SERVICE BULLETIN NO:00007

MODELS : TX-DS989

SUBJECT : The sound of fan is large.

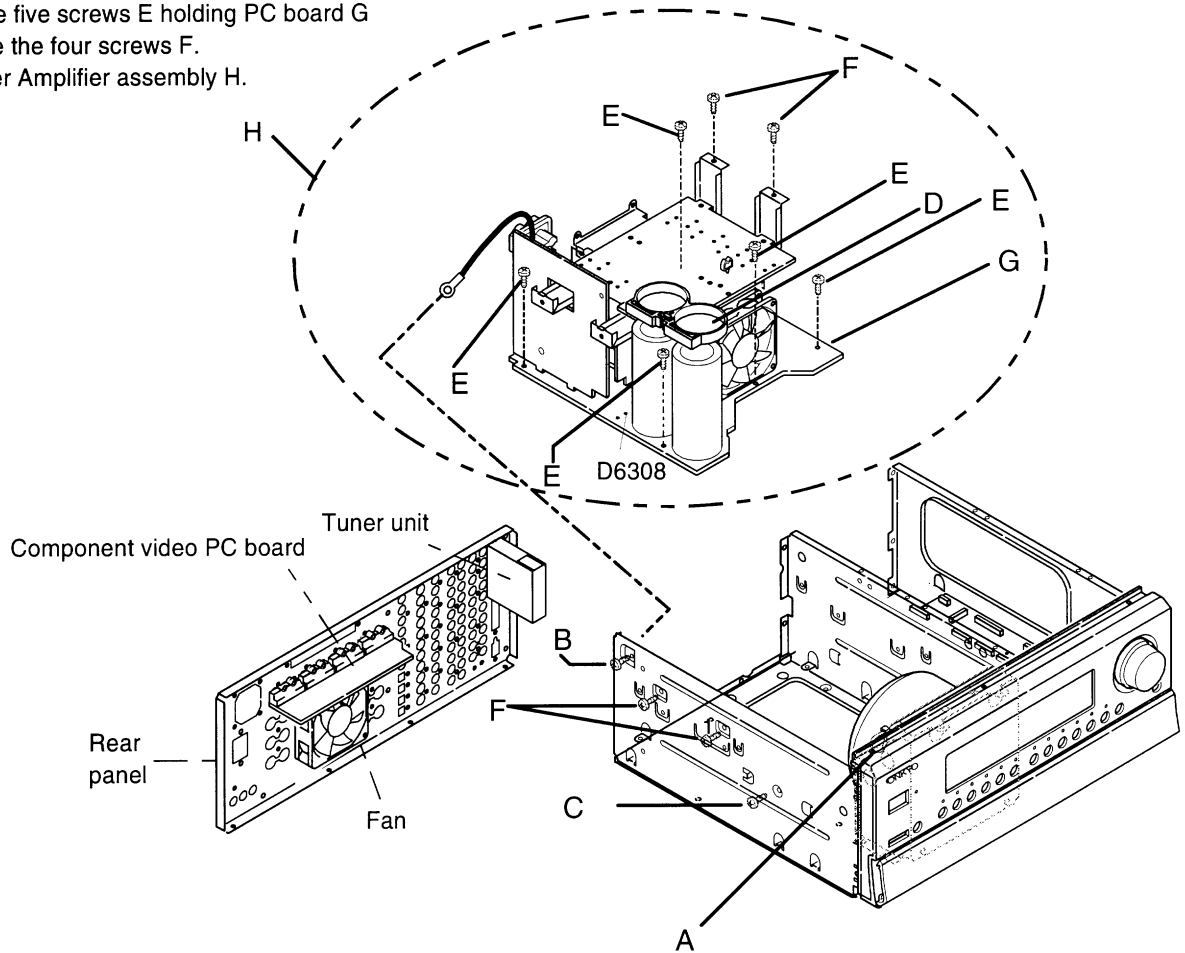
1. Remove the top cover.
2. Remove the screws holding PC boards except the fan, the component video PC board, and the tuner unit on the rear panel.
3. Cut the binder A of the left side on the bracket PT.
4. Remove a screw B.
5. Remove a screw C holding the holder D and remove it.
6. Remove the five screws E holding PC board G and remove the four screws F. Lift up Power Amplifier assembly H.

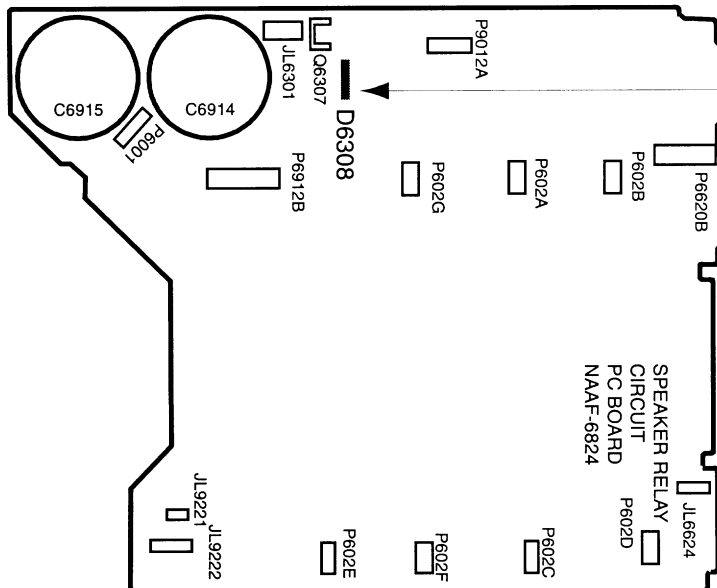
Replace the zener diode D6308 to MTZJ10C on the PC board below.

Change the zener diode to MTZJ10C.
(Part No.224471003)
